## SERVICE BULLETIN

### WHLA7 Flange Mount Axle Versions

CURRENT VERSION OF WHLA7 AXLE  
PRODUCED SINCE (ON OR ABOUT) 01/01  
(DISTINGUISHED BY REINFORCING RING AND  
LARGER BASE HOLE DIAMETER)

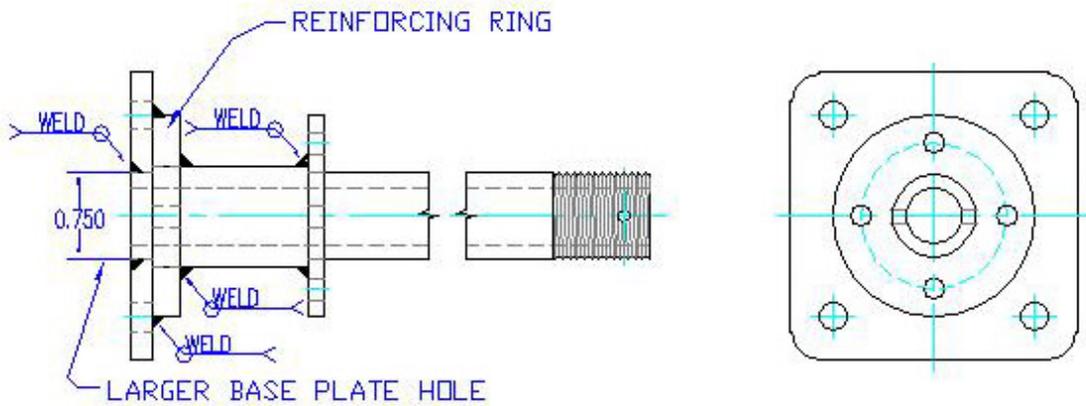
The earlier manufacturer of MATCO mfg products produced the WHLA7 Flange mount axle in several configurations. After acquiring the assets of MATCO mfg in November of 2000, two distinctive changes were made to this axle. The current axle design as shown in the diagram below has been produced since (on or about) January of 2001.

The key aspects that differentiate the current design from that used by the earlier manufacturer is the reinforcing ring welded to the base at the axle flange interface and the larger diameter hole in the flange base that accepts the axle stub.

The current design provides a better interface between the axle stub and the flange base. Although the older design was not produced by the current manufacturer of MATCO mfg products, builders who desire to incorporate the new design may exchange their old style units for \$31.75 each. The exchange must be accomplished by 12/15/05.

It must be noted that the WHLA7 is a heat treated axle and, as such, the structural integrity can be adversely affected (embrittlement) by additional welding. Although there are processing techniques that might be employed, MATCO mfg does not recommend rewelding any of our steel axles and does not perform rework on axles sent here for exchange. Old style axles sent to MATCO mfg will be scrapped rather than repaired.

WHLA7 AXLE MADE BY PRIOR  
MANUFACTURER OF MATCO mfg PRODUCTS
